Model: Model A-P3		Date: 1-May-02	No.: MG065001
Modified Article: Feed Shaft and Tightener Bracket		Prepared by: E. Fukuyama	
From: Technical Services sec. Service Planning Dept.			
Reason for Modification:	☐ Parts catalog correction ☐ To facilitate assembly ☐ Part standardization	☐ Vendor change ☒ To improve reliability ☐ Other	☐ To meet standards ()

The following changes have been made to reduce noise.

Replacement Procedure for parts modified in section A above

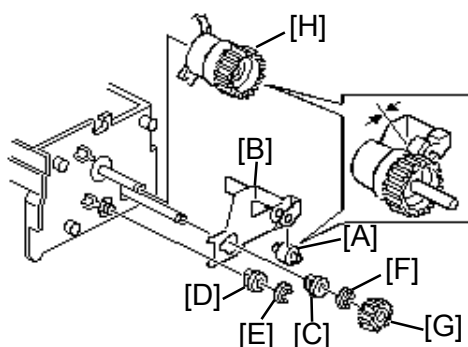
Remove the Tightener Bracket, Retaining Ring, Bushing and Electrical Clutch as shown below.

1. Replace the Feed Shaft with AA140753.

2. Attach the Driven Roller [A] to the Pressure Plate [B], then peel off the outer layers of the double-sided tape (2 places) on the Pressure Plate.
3. Set the Bushing [C] in the hole in the Pressure Plate, then mount the two together onto the Feed Shaft.
Note: Be careful not to let the exposed double-sided tape contact the Side Plate.
4. Set Bushing [D] in the cutout on the side of the Pressure Plate, then push in the Pressure Plate along with the two bushings. After it is set in position, attach e-rings [E] and [F].
5. Press the Pressure Plate firmly against the Side Plate so that the double-sided tape catches and secures the two together.
6. Attach the Gear [G].
7. Attach the Electrical Clutch [H].

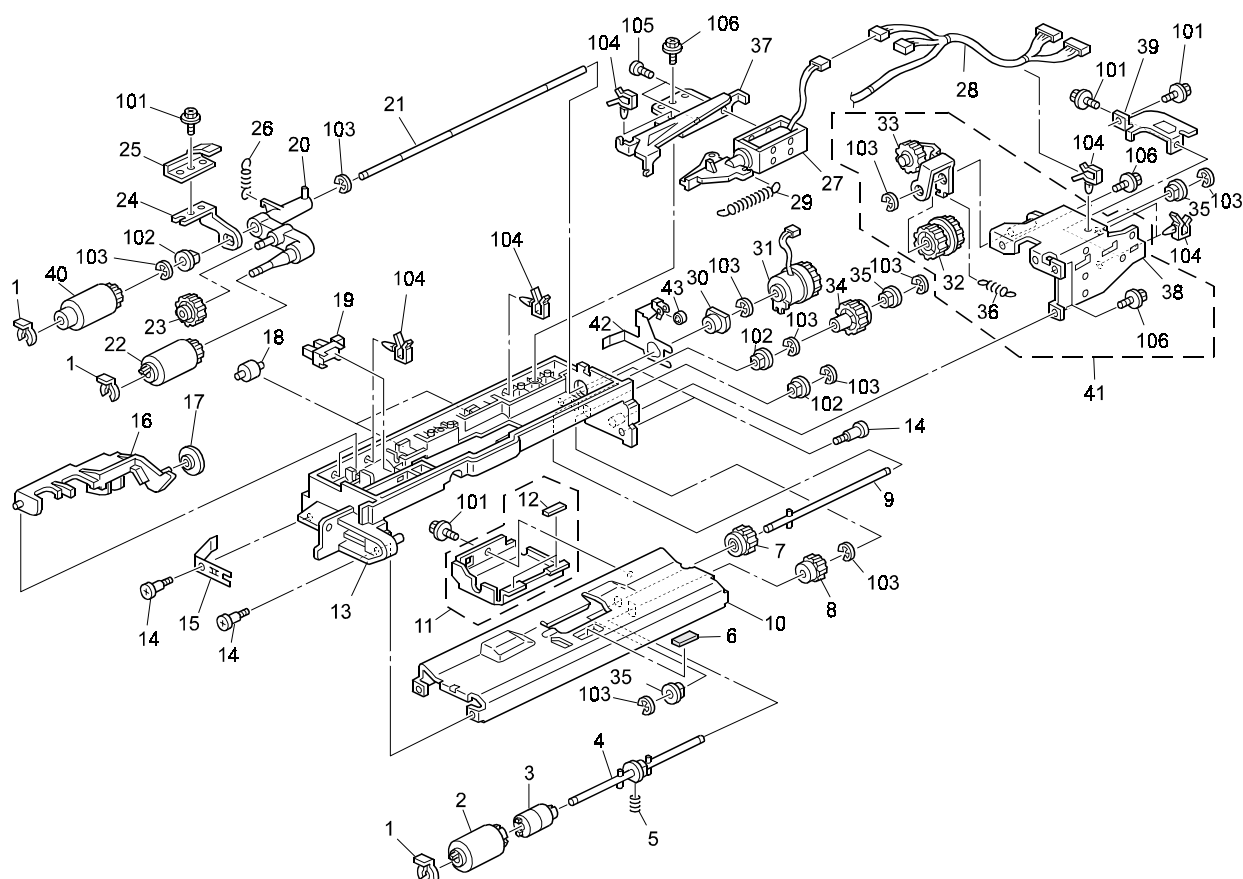
8. Remove the Arm Tightener, Gear and Spring attached to the Tightener Bracket removed in the Prep stage above, then attach them to the new Tightener Bracket [I].
9. Attach the Tightener Bracket [I] and Bushings [J] and [K]. Then, tighten the screws in the order shown.
10. Attach e-rings [L] and [M].

Modified Article: C - Ring - Hot Roller		Prepared by: K.Takagi	
From: Technical Services sec. Service Planning Dept.			
Reason for Modification:	☐ Parts catalog correction	☐ Vendor change	☐ To meet standards ()
	☐ To facilitate assembly	☒ To improve reliability	
	☐ Part standardization	☐ Other

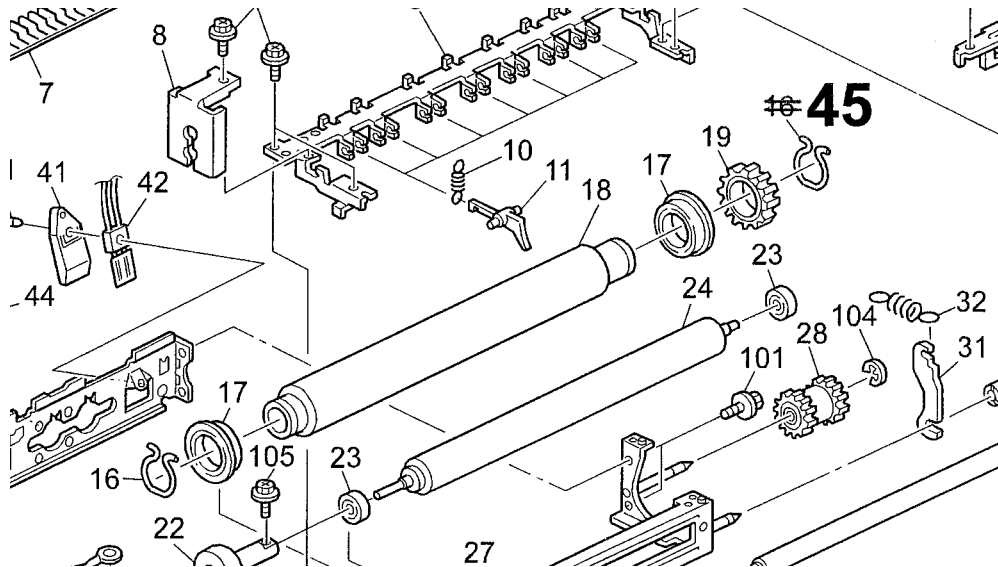
Previously, a pressure-release device was added to the fusing unit maintenance kit to prevent deformation of the Pressure Roller during long periods of storage. However there are cases in the field where this device is not properly removed, and the Hot Roller C-ring detaches when the fusing knob is turned.

The shape of the C-ring ***on the gear side*** has been changed so that it will stay in place even in such cases. Although this only occurs with the maintenance kit, this modification was made because the same C-ring is common to both the kit and the mainframe.

Visual distinction:

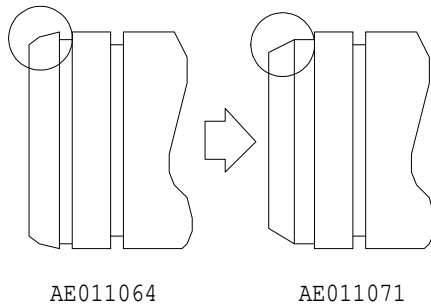
As previously announced in MB #MG065002, the C-ring was modified to ensure that it does not slip off the Hot Roller. However due to variations in roller diameter, it became necessary to separate the thicker rollers out from stock for use on the A-P3. To eliminate this need, and to ensure that all C-rings will stay properly fastened, the outer diameter of the Hot Roller has been increased by 0.2 mm.

The old roller (left) contains a groove on the fusing knob end.

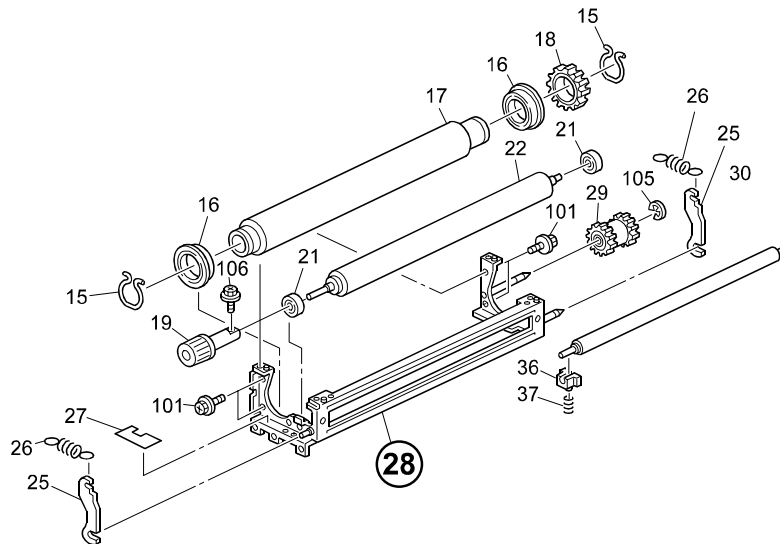
The following has been changed due to a vendor change.

PCU Stopper Spring

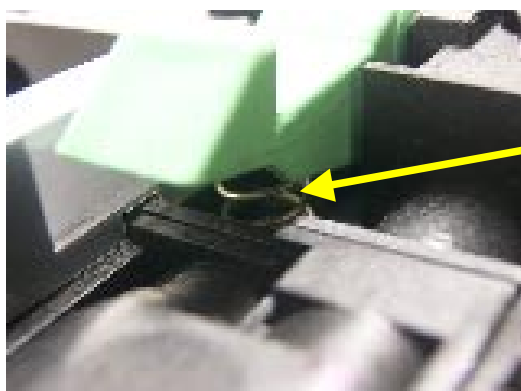
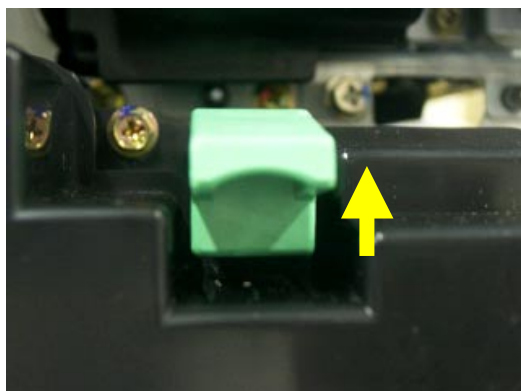
Change: The pressure of the PCU stopper spring was increased (9.8N to 20N).

Reason: To make sure the stopper does not move when drive is supplied to the PCU.

Note: If the stopper moves, the PCU can move out of position a few millimeters. This can cause poor connection of the TD sensor, or incorrect development bias on the development roller.
